**ZONING CHANGE, NEIGHBORHOOD PLAN AMENDMENT, AND ORDINANCE  
AMENDMENT REVIEW SHEET**

**CASE NUMBERS:** East Riverside Corridor Regulating Plan

**Code Amendment Case Number:** C20-2011-003

**Exhibit F:** Staff and Planning Commission recommended amendments to the Sept. 14, 2012 Draft East Riverside Corridor Regulating Plan

**Figure 1-5: East Riverside Corridor Collector Street Map**  
Shows existing and new streets designated as Collector streets.

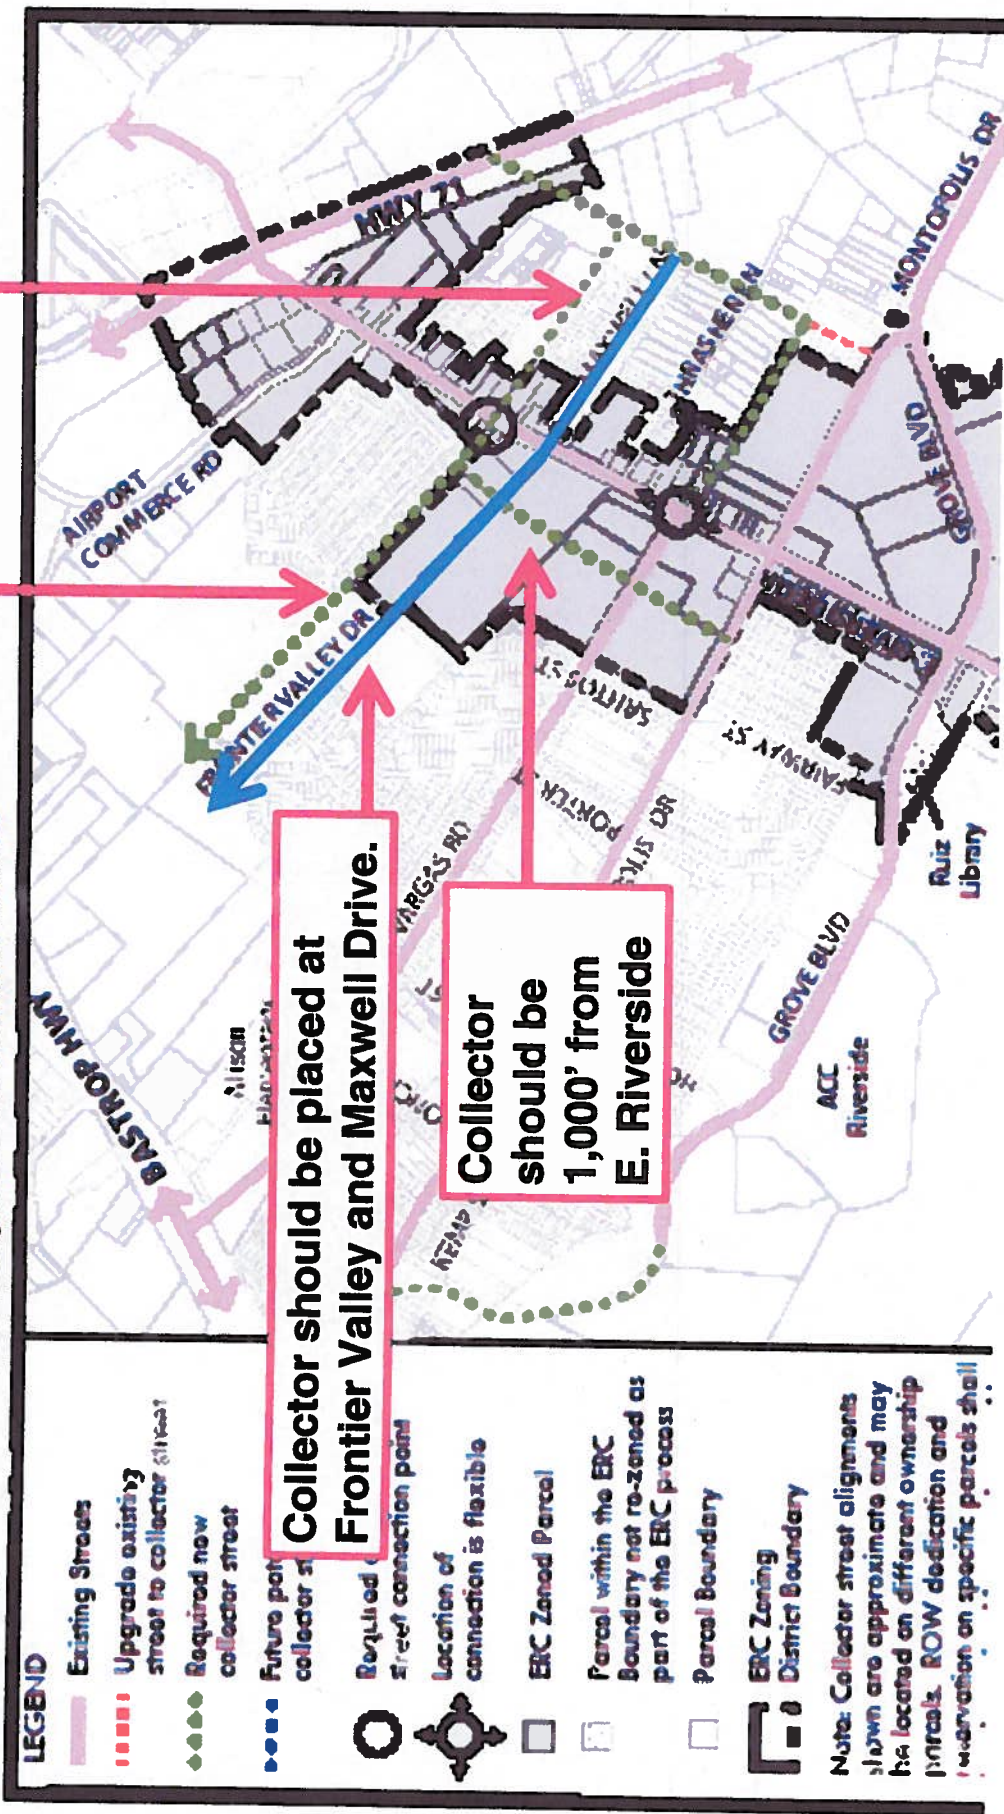
5	15	Figure 1-5	Collector Street Map	Easternmost north-south collector runs through a mile of drainage easement, flood plain and utility infrastructure. Costs of construction is doubled.	Relocate collector roadway to Frontier Valley / Maxwell. Existing roads are in place and less costs necessary for any upgrades to collector roadway.

Item	Page	Section	Relates to	Issue	Solution
6	15	Figure 1-5	Collector Street Map	Easternmost collector located parallel and north of E. Riverside Drive is located too close to E. Riverside Drive.	Consider moving collector north to provide for greater distance from E. Riverside Drive. This collector will be heavily used as it connects all development from Montopolis and east to Frontier Valley.
7	15	Figure 1-5	Collector Street Map	Westernmost collector located parallel and north of E. Riverside Drive is unlikely location for collector roadway due to proximity to E. Riverside Drive.	Consider relocating further north or eliminating. The triangle roadway system of E. Riverside, Tinnin Ford and Lakeshore is ample. OR consider downgrading to alley for commercial services along E. Riverside.
8	16	Figure 1-6	Hub Map	HUB boundaries are not large enough to reflect greater density needs versus lower densities actually constructed.	Enlarge HUB boundaries to 1/2 mile and increase subdistrict boundaries accordingly.
